Proposed changes for addressing comments #12, #19, #20, #25 and #26 against P802.1DU/D0.3

Author: Johannes Specht

Date: 2024-09-11

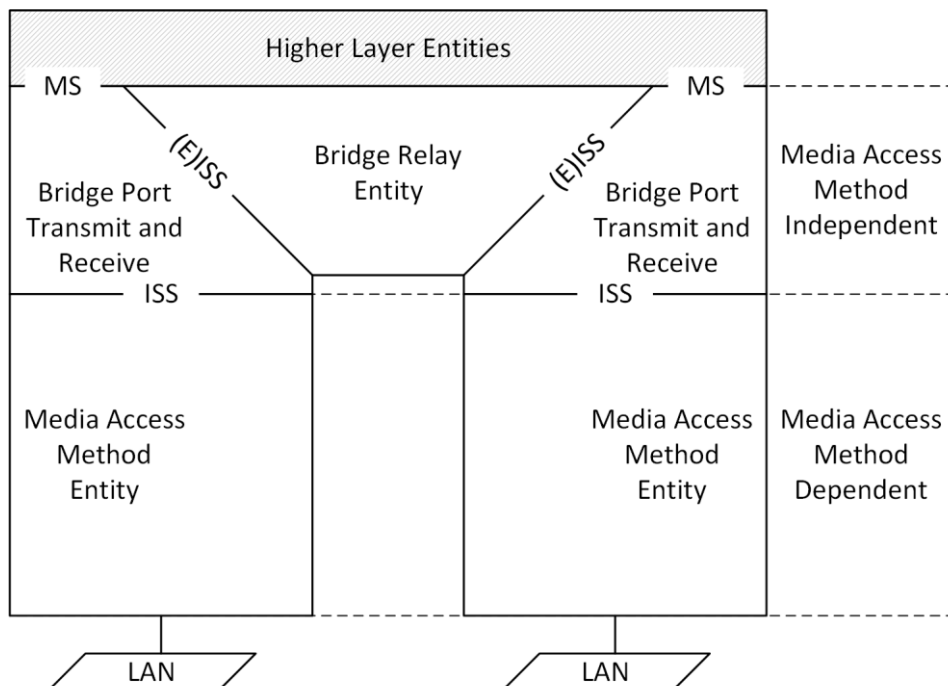
Comments #19, #20

*** Replace Figure 6-1 with the following:**
